Field Safety Notice

Notification Update

CombiDiagnost R90 and ProxiDiagnost N90

Component damage due to short circuit & table stop due to broken tabletop cable

Figure 1. Image of damaged cable

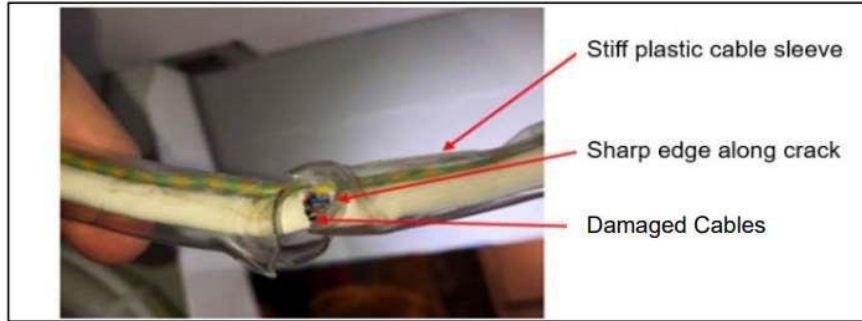
On the ProxiDiagnost N90 table there is a cable located under the tabletop that is covered by a plastic sleeve which can crack and damage the cable (see Figure 1). If the tabletop cable is damaged or breaks, the user may not be able to initiate table tilting movements. However, if the cable breaks, the braking mechanism is released, but the system is counterbalanced in all directions which prevents movement of the table. The table can still be brought back to 0° position using the Tilting Switch and the patient can be safely moved off the table.

A Philips Field Service Engineer (FSE) will visit impacted customer sites to replace the tabletop cable to prevent the issue from occurring.
